# Town of Mammoth Lakes

## Advisory Design Panel Staff Report

<b>Date:</b>	February 14, 2019	<b>File No.:</b>	Major Design Review (DR) 18-006
<b>Place:</b>	Town & County Conference Room, 2 <sup>nd</sup> Floor Minaret Village Shopping Center Mammoth Lakes, CA 93546	<b>Project:</b>	Yotelpad
<b>Time:</b>	After 2:00 p.m.	<b>Location:</b>	6040, 6042, 6060 Minaret Road
<b>Appeal Status:</b>	Not Applicable	<b>General Plan:</b>	North Village Specific Plan (NVSP)
<b>Applicant / Owner:</b>	RePlay Destinations - Chris Heinrich / One Mammoth, LLC	<b>Specific Plan:</b>	North Village Specific Plan (NVSP)
<b>Environmental Review:</b>	Conformance review with the existing North Village Specific Plan Environmental Impact Report	<b>Zoning:</b>	North Village Specific Plan (NVSP)

**TITLE:** Yotelpad Design Review

## SD REFERENCE NOTES

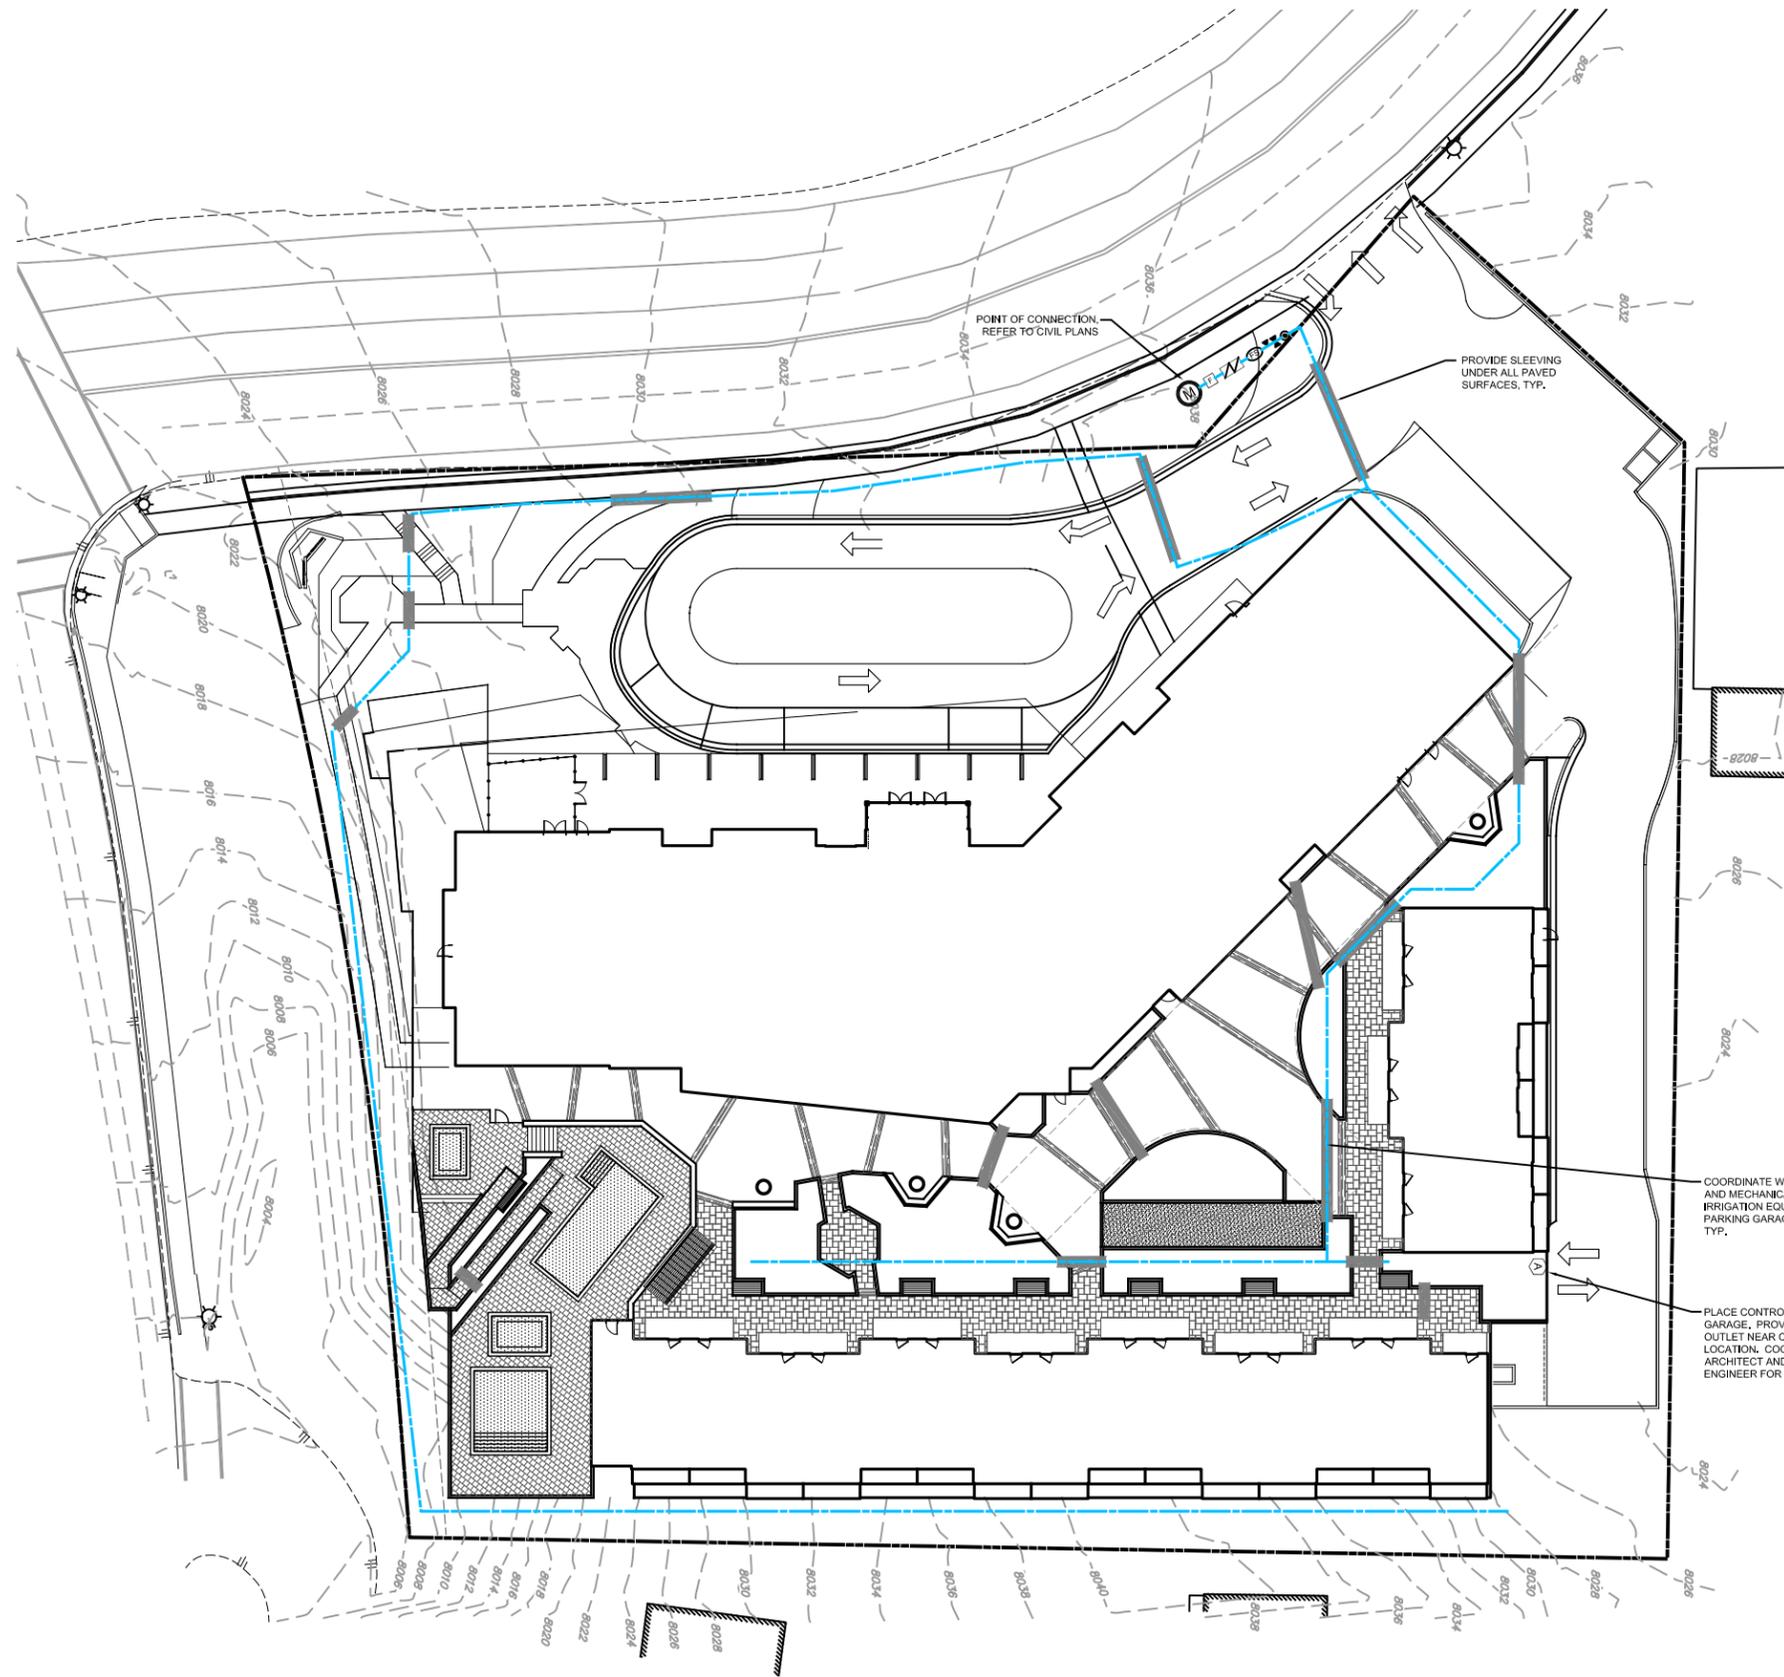
1. Pedestrian circulation is an issue and the project, as designed, is not consistent with the North Village Design Guidelines related to pedestrian connectivity. The front parking area impedes pedestrian connectivity to the Village and the visual of the parking lot and adjacent sidewalk as you turn from Main Street and Minaret Road appears as a "sidewalk in the middle of a freeway." The pedestrian area on the corner will be limited to summer use only and will be oftentimes windy.

2. The southwest corner of the site is the most visible location in Town and to use it as a parking lot is a loss. Consideration should be given to developing that corner with hotel guest uses (i.e., lobby area or restaurant space) to animate that corner and add visual interest and provide a buffer between the street and the rest of the project.

- Response:
    - The SW Corner has been re-designed to address pedestrian connectivity (Refer to Drawing F.2 & H.1) to the sidewalk along Minaret and to the crosswalk on the corner of Minaret and Mainstreet.

- Response:
    - The SW Corner has been re-designed to animate the corner by re-focusing the restaurant patios (Refer to Drawing F.1, F.2 & H.1).
    - The arrival valet area has been greatly reduced in size and all parking has been eliminated. The arrival valet area has also screened with landscaping, landscaping walls, etc. (refer to drawings G.4 and F.1)

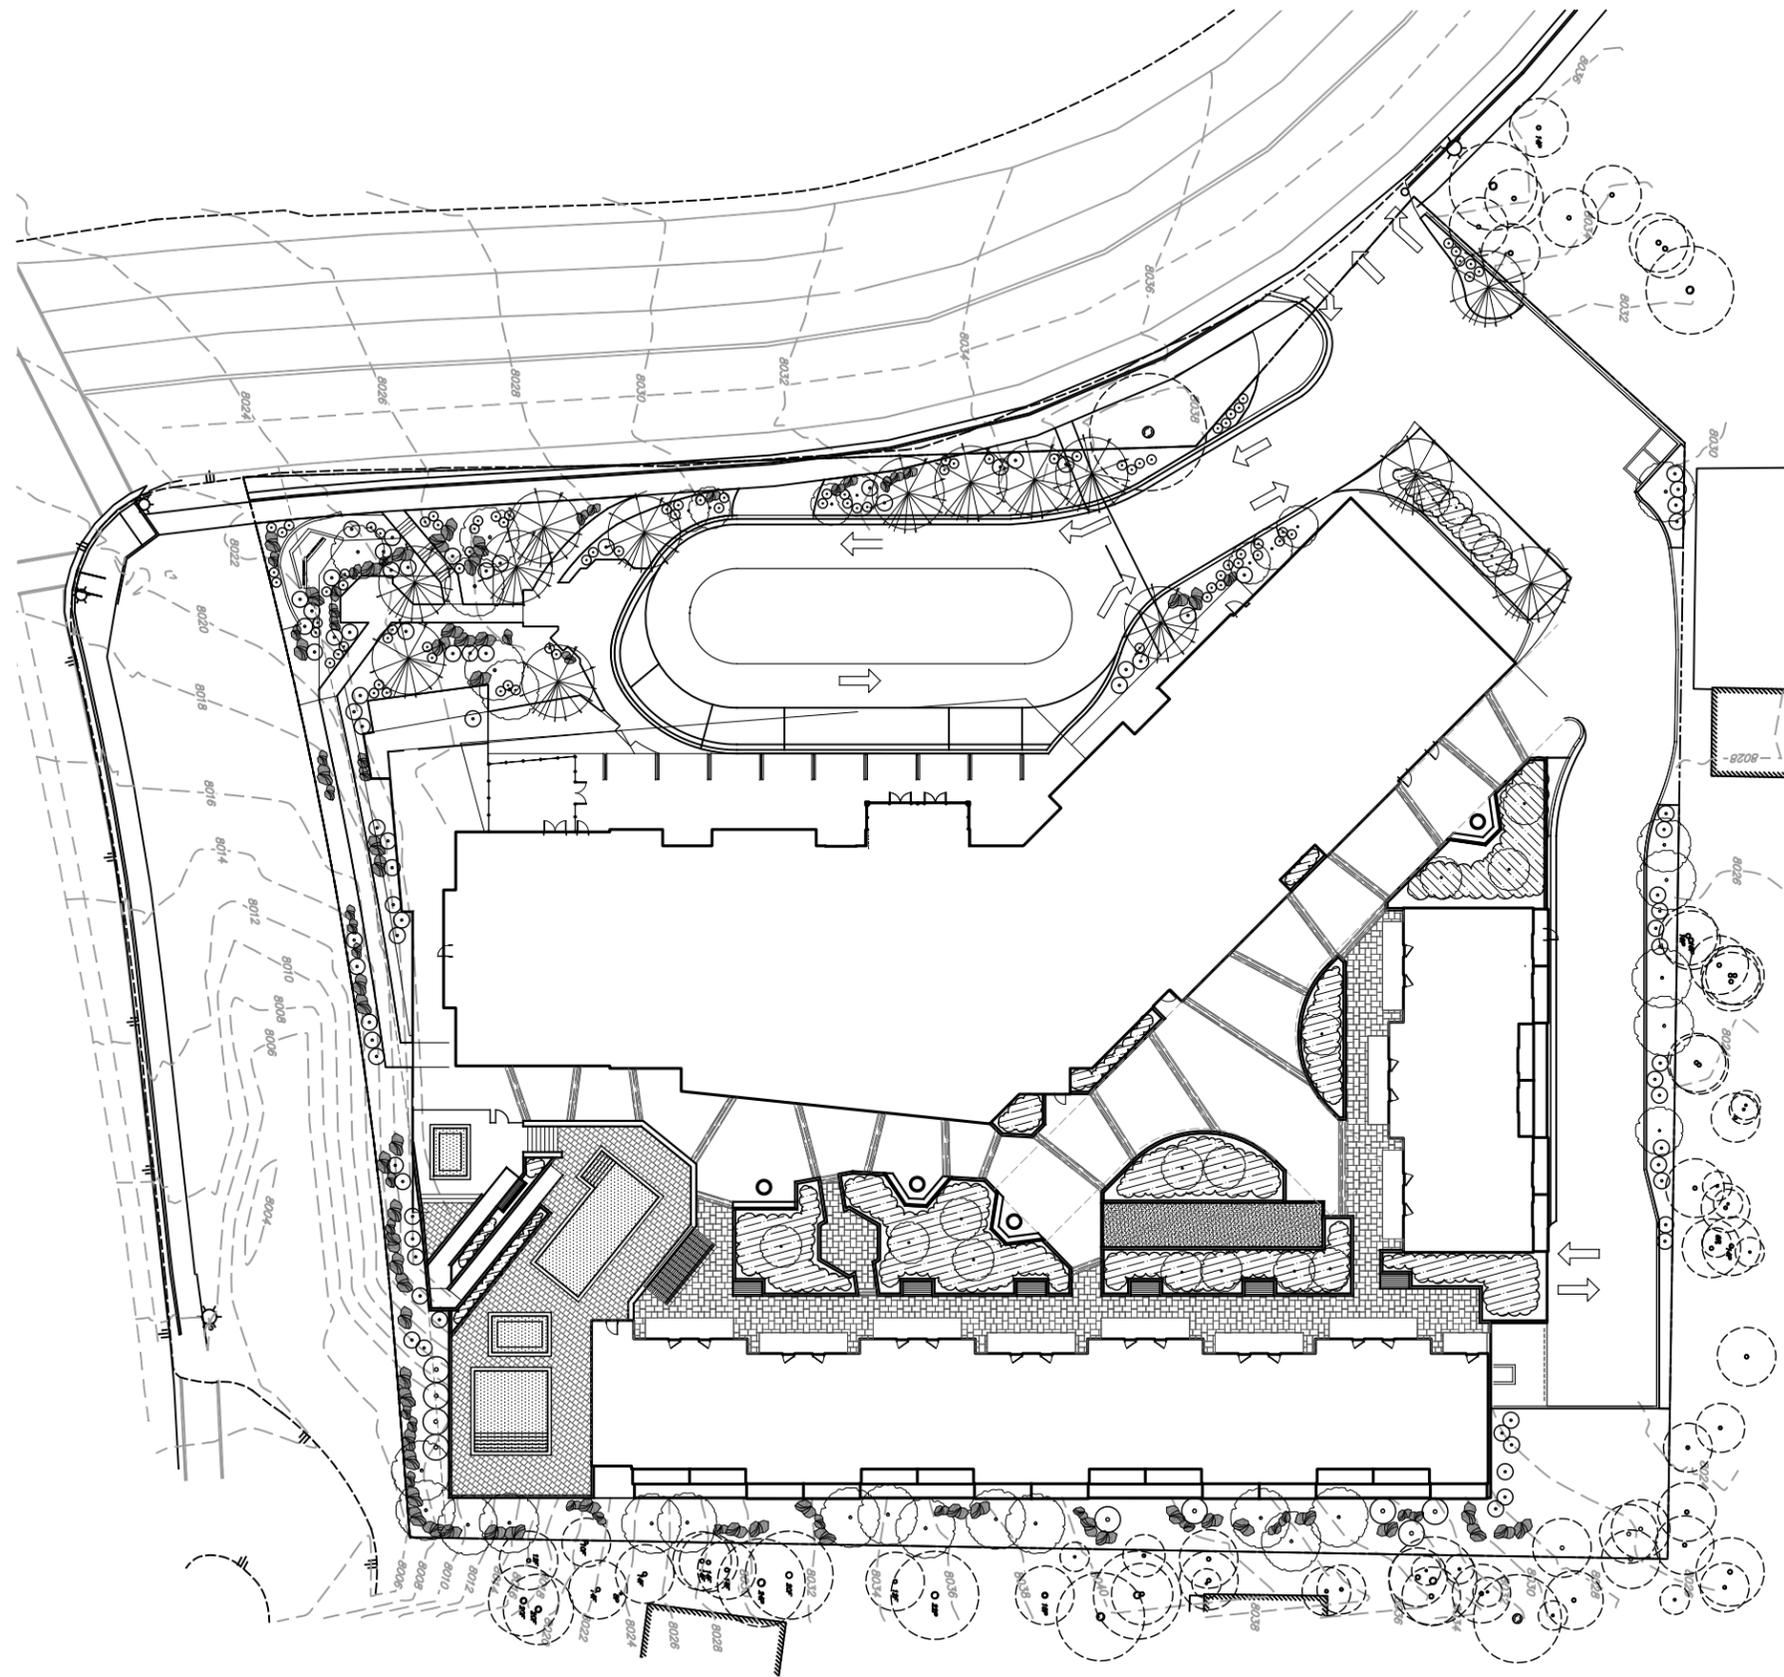
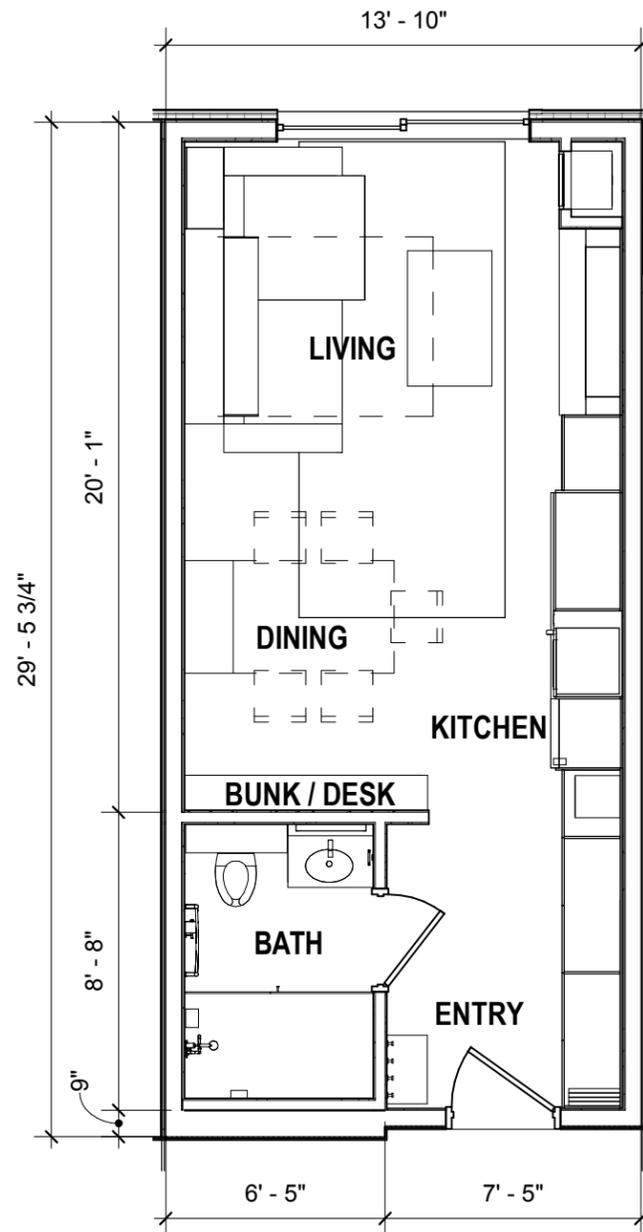
19. The snow storage plan needs to address temporary snow storage areas and snow hauling. The applicant indicated that the courtyard will be heated.
20. The landscape plan should use native trees and use trees that are larger than five gallons. Landscaping on the southwest corner of the site could be a focal point and have additional landscape features (i.e., terracing, variety of trees and plants, sign) and a pedestrian pathway that meanders through that area and connects to the Main Street sidewalk.

5. The site design should take advantage of the existing vegetation around the site and preserve as many trees as possible, especially near the southwest corner of the site.

- Response:
    - All of the large existing trees within the Caltrans right-of-way will be reserviced (refer to drawing G.5).
6. The project appears to have landed on the site and is not integrated into the natural slope of the site nor does it consider the transitions between adjacent properties. Some ideas for better integration into the site include: (1) using natural boulders that are stacked for retaining walls, rather than an engineered block retaining wall; (2) terracing or stepping the parking down; (3) terracing the landscaping up from the street with landscaped knolls; or (4) working the entire building into the grade.
